No. E 8486 of 1917.

With reference to his application dated 31st August 1917 with plans for the proposed cabin on the top floor of his house under construction on plot No. 125, A-23 Napier Quarter Mr. Rihumal Bilaram is informed that the same being contrary to the bye-laws No. 233 can not be permitted. The plans are herewith returned disapproved.

I beg to submit a plan for
cabin on 3rd floor to building on
plot no 125 that a 23 paper Quarter

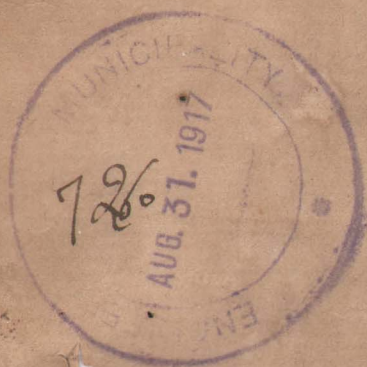
I beg to report that
 the plot in question has
 one frontage and the width
 of the street is 20 feet. in
 accordance with the byelaws
 no part of the building
 can be ~~erected~~ allowed
 to exceed double the
 width of the street. Respect
 yours one
